ADDENDUM NO. 1

TERRY CARGIL RESERVOIR

LACEY CONTRACT NO. PW 2019-32

CONDUITS AT TOP LANDING 4
SCALE: 1/2" = 1'-0" E-13

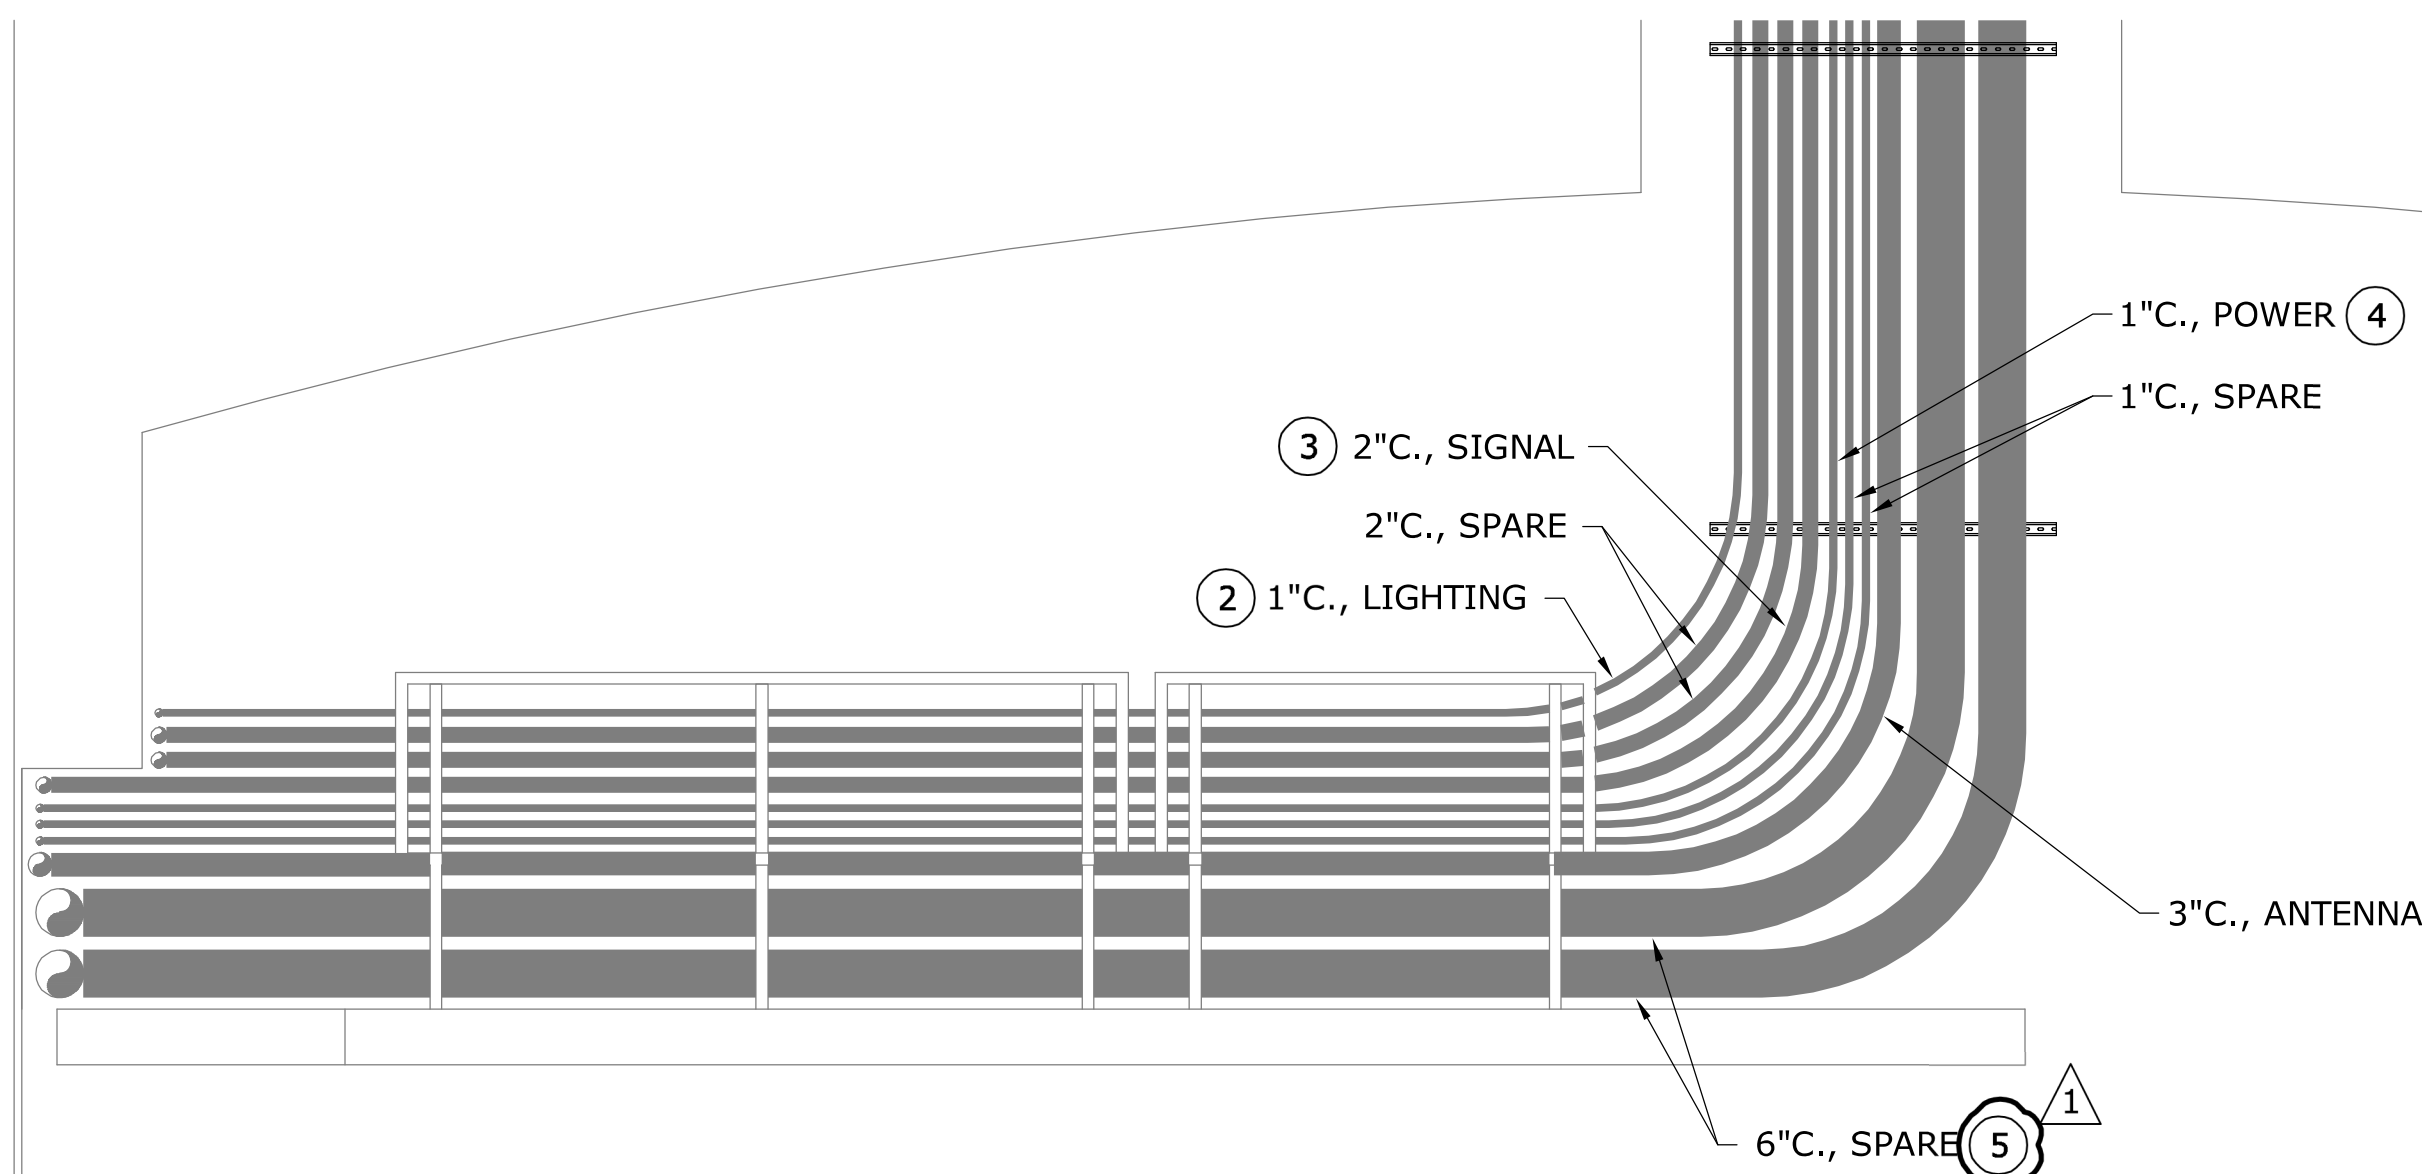
- 1) *The revisions include changes to notes related to the 6-inch diameter spare conduits.*
Delete Sheet E-13 / Page 59 of 62 and replace it with the new page as attached.

5 ALTERNATE OPTION: CONTRACTOR MAY INSTALL (4) 4-IN "SPARE" CONDUITS IN LIEU OF THE (2) 6-IN "SPARE" CONDUITS. MAKE ADJUSTMENTS TO WIREWAYS (PULL BOXES) AS REQUIRED. CONTRACTOR MAY TERMINATE (2) 4-IN "SPARE" CONDUITS PER WIREWAY OR USE (4) INDIVIDUAL WIREWAYS. WIREWAYS (PULL BOXES) TO BE SIZED PER NEC 314.28.
